Office Action Summary	Application No. 10/671,490	Applicant(s) CHUNG ET AL.	
	Examiner Jyoti Nagpaul	Art Unit 1743

DETAILED ACTION

4. **Claims 1-16** are rejected under 35 U.S.C. 103(a) as being unpatentable over McNeely (US 6591852).

FIG. 2D

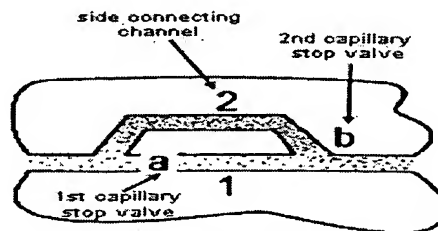
5. McNeely discloses methods and apparatus for controlling fluid flow through microchannels. The apparatus comprises at least one side connecting channel (2) connecting a first capillary stop valve (a) to a second stop valve (b). The capillary stop valves (a and b) stop the flow of the fluid using the surface tension of the fluid. (See Example 1) Additionally, the flow of fluid through the side connecting channel (2) opens the capillary stop valves (a and b). (See Figure below) The apparatus further comprises at least one flow delay part, surface modification and/or channel geometry, is formed within the side connecting channel (2). (See Col. 5, Lines 50-59) (See Col. 7, Lines 33-46) McNeely further teaches the side connecting channel adjust the surface tension by at least one of increasing a width of the path, decreasing a width of the path and performing surface modification or temperature change so that the fluid reliably moves. (See Col. 7, Lines 31-46)

McNeely fails to explicitly teach the first and second stop valves as disclosed above in a microchannel arrangement comprising at least one storage chamber, at least one reaction chamber and at least one exhaust chamber. McNeely further fails to explicitly disclose the first capillary stop valve (a) is located between the at least one storage chamber and the at least one reaction chamber. McNeely further fails to teach the second capillary stop valve (b) is between the at least one reaction chamber and the at least one exhaust chamber.

FIG. 10B

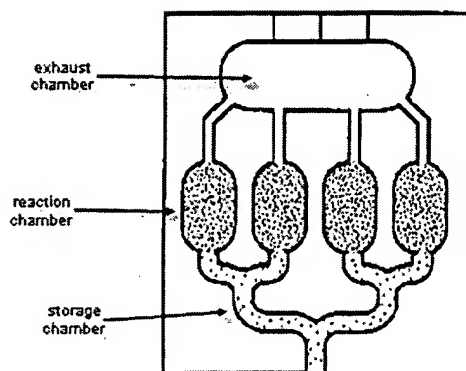
However, McNeely does disclose the mixing fluids using the above embodiment in more complex models in which more channels or wells are involved can be utilized for controlling the fluid flow of more than one fluid through the channel and increasing gradual and uniform mixing of the fluids. (See Col. 7, Lines 48-53 and Col. 11-12, Lines 40-8) Additionally, Figures 10A-10C describe a microchannel model comprising a storage chamber to which a fluid is injected and stored, at least one reaction chamber in which a predetermined reaction occurs on the fluid, at least one supply channel communicating fluid from each storage chamber to the at least one reaction chamber and at least one exhaust chamber in which fluid used as a result of the reaction is exhausted. (See for example figure 10B below) McNeely further teaches at least one storage chamber includes a fluid inlet operable to receive fluid.

Therefore, the disclosure of McNeely suggests that it would have been obvious to one of ordinary skill in the art to combine the different embodiments disclosed above by McNeely to produce the desired microchannel device to evenly distribute fluid across all the channels.
